R20TS0896EJ0100

RX Family

Flash Module Using Firmware Integration Technology

1. Notes on the Application Note Sections "5.3.1.1 Programming Code Flash from RAM" and "5.3.1.2 Programming Code Flash Using the Dual Bank Function"

1. 5.3.1.1 Programming Code Flash from RAM

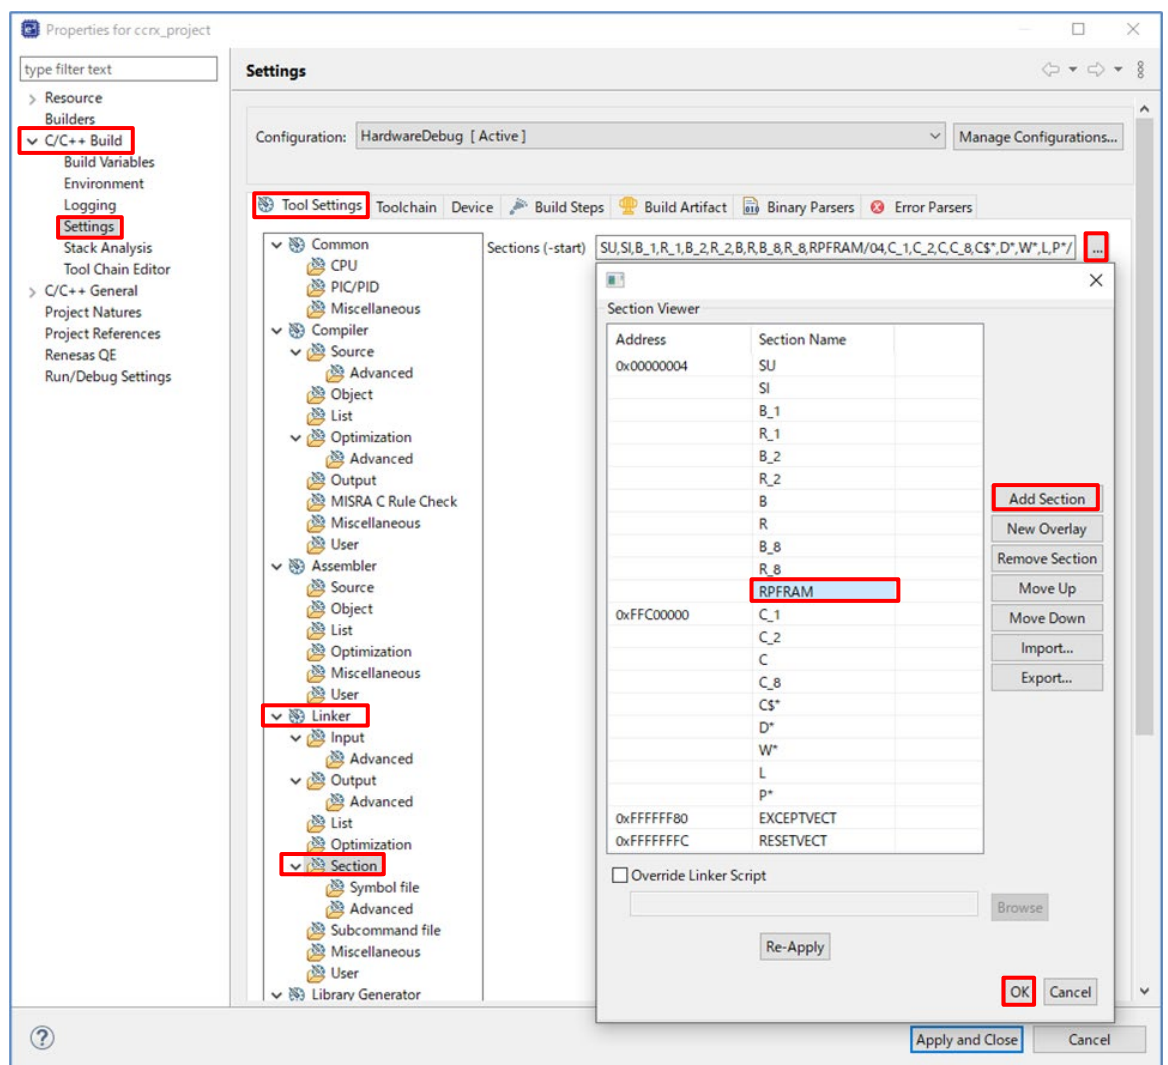
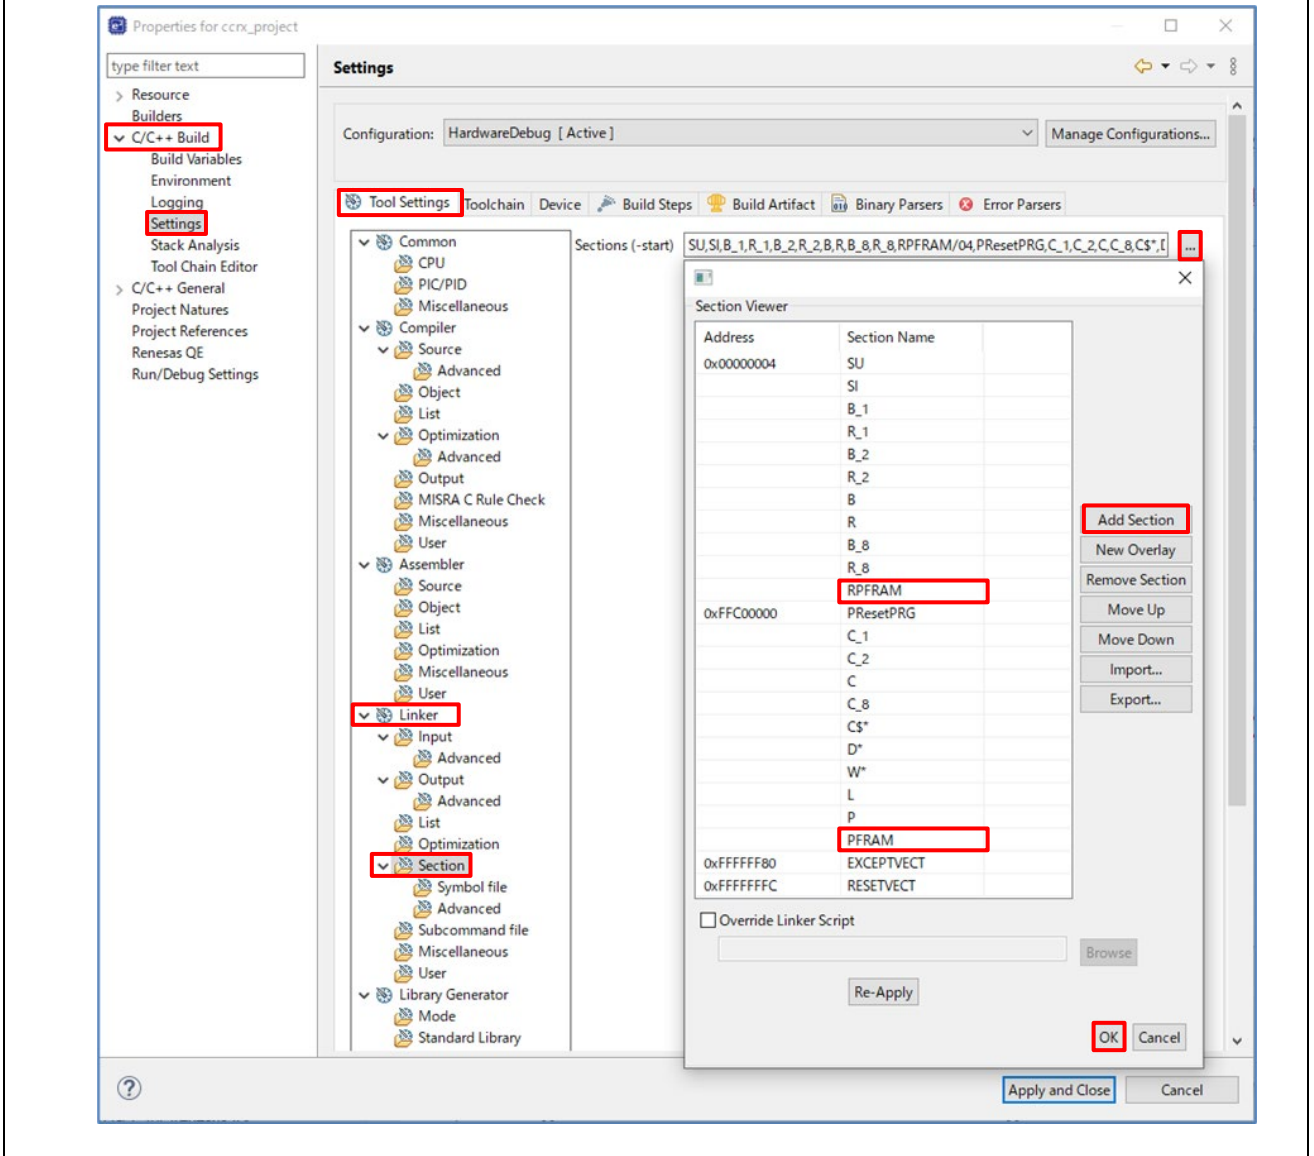
See the application note for Flash Module Rev. 4.90, page 84, "1. Add a 'RPFRAM' section in a RAM area". Change the procedure as follows.

Procedure on 5.3.1.1

1. Add a 'RPFRAM' section in a RAM area.

- (1) In Project Explorer, click the project you want to debug.
- (2) Click File > Properties to open the Properties window.
- (3) On the Properties window, click C/C++ Build > Settings.
- (4) Select the "Tool Settings" tab, click Linker > Section, and click the [...] button to display the Section Viewer window.
- (5) On the Section Viewer window, click the [Add Section] button to add a 'RPFRAM' section in a RAM area, and then click the [OK] button.

Correct procedure

1. Add a 'RPFRAM' section in a RAM area.

- (1) In Project Explorer, click the project you want to debug.
- (2) Click File > Properties to open the Properties window.
- (3) On the Properties window, click C/C++ Build > Settings.
- (4) Select the "Tool Settings" tab, click Linker > Section, and click the [...] button to display the Section Viewer window.
- (5) On the Section Viewer window, click the [Add Section] button to add a 'RPFRAM' section in a RAM area.
- (6) On the Section Viewer window, click the [Add Section] button to add a 'PFRAM' section in a ROM area, and then click the [OK] button.**

2. 5.3.1.2 Programming Code Flash Using the Dual Bank Function
See the application note for Flash Module Rev. 4.90, page 86, "1. Add a 'RPFRAM2' section in a RAM area". Change the procedure as follows.

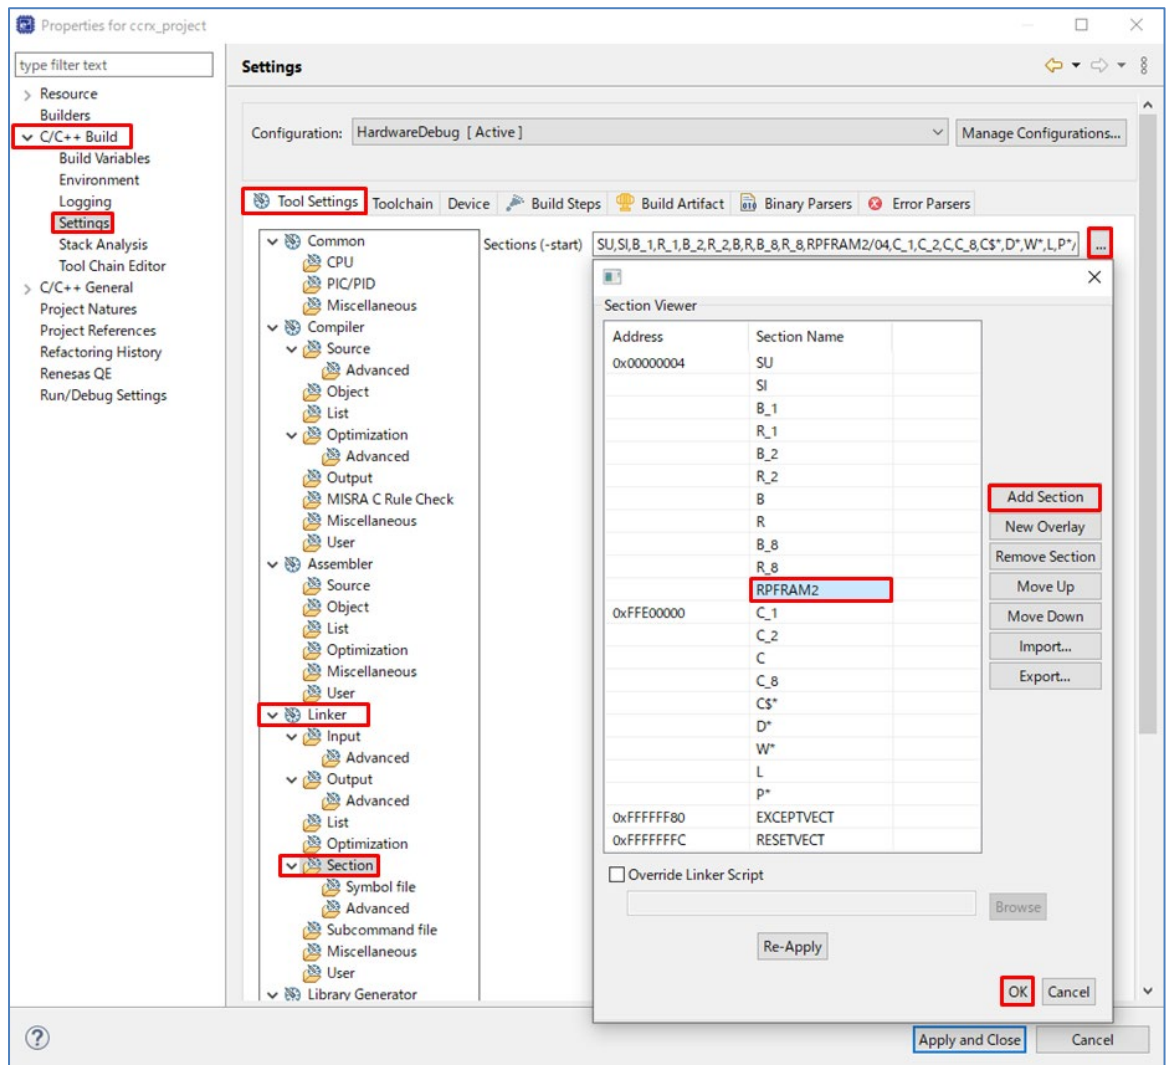
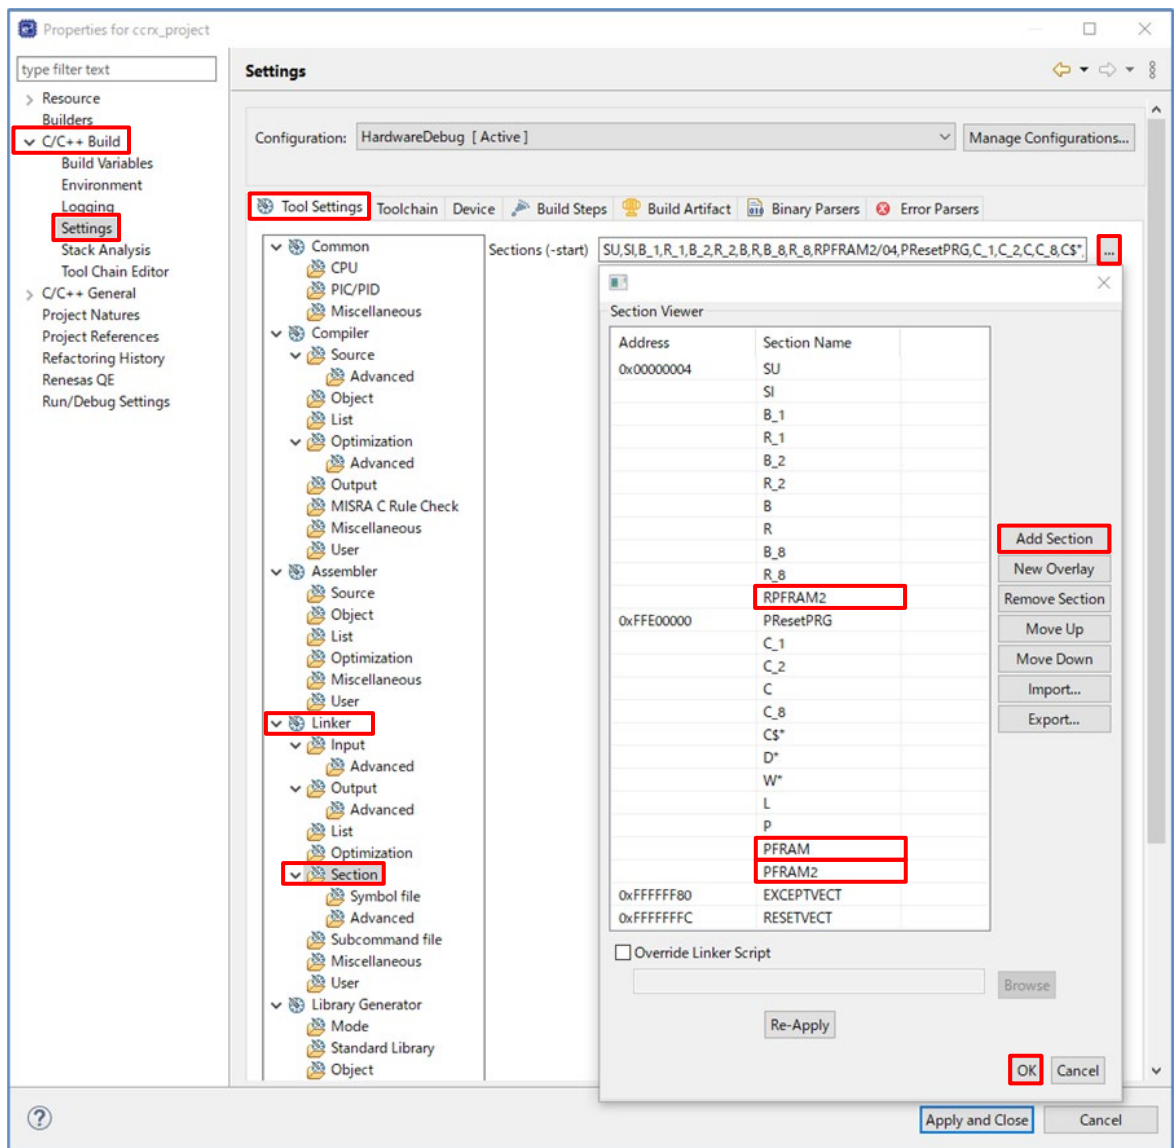
Procedure on 5.3.1.2

1. Add a 'RPFRAM2' section in a RAM area.
 - (1) In Project Explorer, click the project you want to debug.
 - (2) Click File > Properties to open the Properties window.
 - (3) On the Properties window, click C/C++ Build > Settings.
 - (4) Select the "Tool Settings" tab, click Linker > Section, and click the [...] button to display the Section Viewer window.
 - (5) On the Section Viewer window, click the [Add Section] button to add a 'RPFRAM2' section in a RAM area, and then click the [OK] button.

Correct procedure

1. Add a 'RPFRAM2' section in a RAM area.

- (1) In Project Explorer, click the project you want to debug.
- (2) Click File > Properties to open the Properties window.
- (3) On the Properties window, click C/C++ Build > Settings.
- (4) Select the "Tool Settings" tab, click Linker > Section, and click the [...] button to display the Section Viewer window.
- (5) On the Section Viewer window, click the [Add Section] button to add a 'RPFRAM2' section in a RAM area.
- (6) On the Section Viewer window, click the [Add Section] button to add a 'PFRAM' section in a ROM area.
- (7) On the Section Viewer window, click the [Add Section] button to add a 'PFRAM2' section in a ROM area, and then click the [OK] button.
